Release Note

Edgecore EAP105 Release v12.6.6 Document # EAP105-v12.6.6-2513-5d3ae89c2-b4b15ff

Enhancement from v12.6.3-2386-73ec2ed0-d9c6975

1.1 Support Wireless and BLE Presence Data

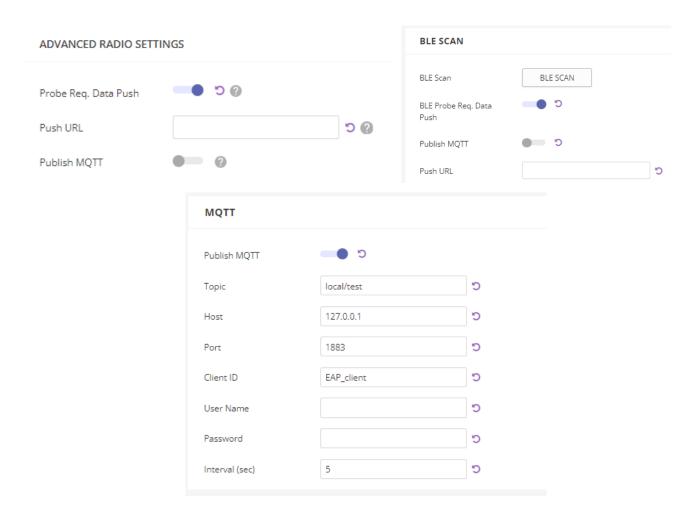
In ecCLOUD, on the radio settings page, if Probe Req. Data Push is enabled, the 2.4GHz or 5GHz radio probe data can be pushed to a URL or an MQTT server.

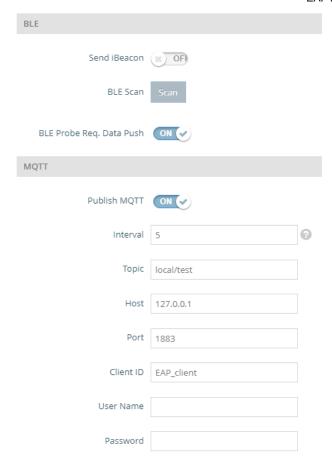
On the service settings page, if BLE Probe Req. Data Push is enabled, the BLE scan data can be pushed to a URL or an MQTT server.

The MQTT interval can be set between 5 and 600 seconds.
